UNITED STATES PATENT AND TRADEMARK OFFICE

APPLICATION NO.	FILING DATE	FIRST NAMED INVENTOR	ATTORNEY DOCKET NO.	CONFIRMATION NO.
10/737,330	12/17/2003	Michael Anthony Zerillo		7560

Office Action Summary

DETAILED ACTION

Small, Figure 2

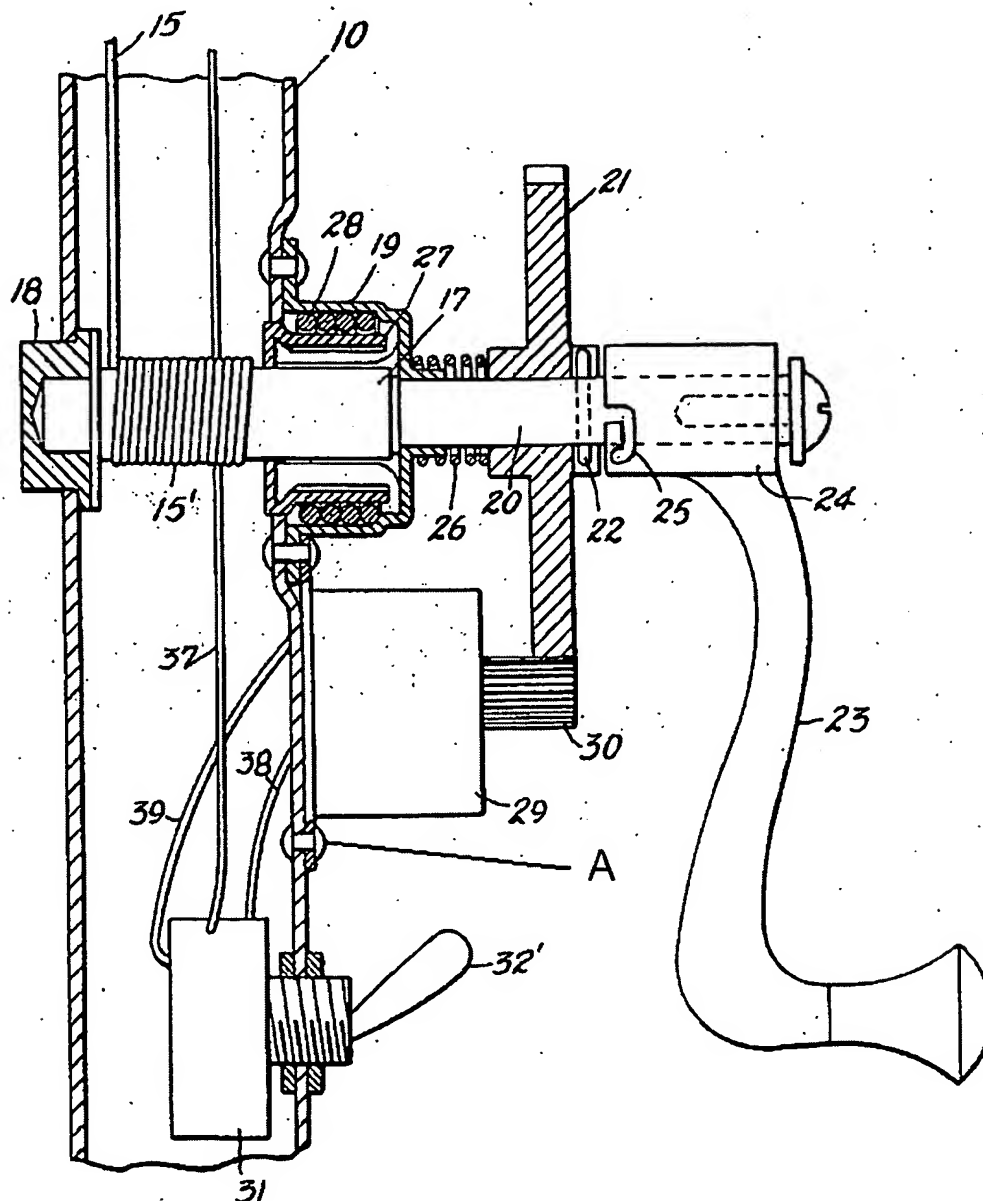
2. Claim 1 is rejected under 35 U.S.C. 103(a) as being unpatentable over Lai in US Patent 6182917 in view of Small in US Patent 2960094. Lai discloses a "retrofit" electric opening and closing device for new and existing umbrellas, the device comprising a reversible electric motor (21), a reel drivingly engaged with the motor (24) a housing means for the motor and the reel (12), a length of cable (33) affixable at one end to the reel, a means to provide electricity (See Lai, Column 2, lines 14-15), a switch (10) having two means (See Lai, Column 4, lines 12-15) to connect or disconnect the electricity to the motor, a remote control receiver (11) having two means (See Lai, Column 4, lines 12-15) to connect or disconnect the electricity to the motor, and a remote control transmitter (See Lai, Column 1, lines 26-28) having means to control the remote control receiver. Lai is silent on which direction the motor turns it relates to the controlling element of the switch or remote receiver. However, it would be obvious for the engagement of a first means in a controlling element such as a switch or a remote receiver to connect electricity to the motor and cause the motor to turn in a first direction of rotation thereby causing the umbrella to open, and for disengagement of the first

means of a switch or remote control receiver to disconnect electricity from the motor and cause it to stop rotating in a first direction thereby causing the umbrella to stop opening. Further, it would be obvious for the engagement of a second means in a controlling element such as a switch or a remote receiver to connect electricity to the motor and cause the motor to turn in a second direction of rotation thereby causing the umbrella to close, and for disengagement of the second means of a switch or remote control receiver to disconnect electricity from the motor and cause it to stop rotating in a second direction thereby causing the umbrella to stop closing. Lai does not disclose that the opposite end of the cable is affixable to the patio umbrella opening and closing means, nor does he disclose a means to affix the housing to the patio umbrella at a location to thereby establish control of the patio umbrella opening and closing means. Small discloses a motor device for an umbrella, the device having a cable (15) affixed at one end to a reel (17), the opposite end of the cable being affixable (See Small, Column 1, lines 50-54) to the patio umbrella opening and closing means (13). Small also discloses a means (A) to affix the housing to the patio umbrella at a location to thereby establish control of the patio umbrella opening and closing means. It would have been obvious to one of ordinary skill in the art at the time of invention to modify the device of Lai by using a cable attached at an opposite end to the patio umbrella opening and closing means and to use a means to attach the housing a location to thereby establish control of the patio umbrella opening and closing means as taught by Small in order to ensure that the motor is in control of the operation of the umbrella and that it is firmly attached at a convenient position to the umbrella. Please note that it has been held that

the functional “whereby” statement does not define any structure and accordingly can not serve to distinguish. Therefore, the limitation “whereby a person with ordinary skill can attach the device to the opening and closing means of the patio umbrellas with little or no modification” has been given no patentable weight. *In re Mason*, 114 USPQ 127, 44 CCPA 937 (1957).
